Service Bulletin TV Products

Model: KP-53XBR45, KP-61XBR48 No. 388

Subject: Fuse resistor not listed Date: January 20, 1999

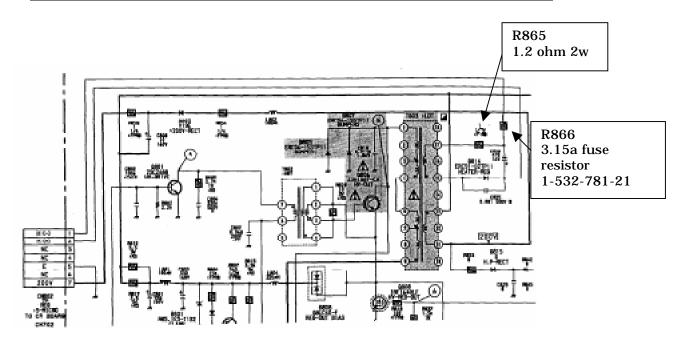
(1311) No picture CRT filament is not lit. Fuse resistor R-866 is open. This resistor is not

listed in the Service Manual parts list or show in the schematic.

The E board was changed starting with Suffix –14. When fuse resistor R866 and R865 was added. Please see the schematic and Ref. chart below for the proper Part Number and schematic diagram.

This resistor is located between T-803/pin 17 and CN-802/pin 1. R-865 is in series with this fuse resistor.

Ref.	Description	Part Number
R865	1.2 ohm 2 watt resistor	1-216-370-11
R866	3.15a Micro Fuse resistor	1-532-781-11
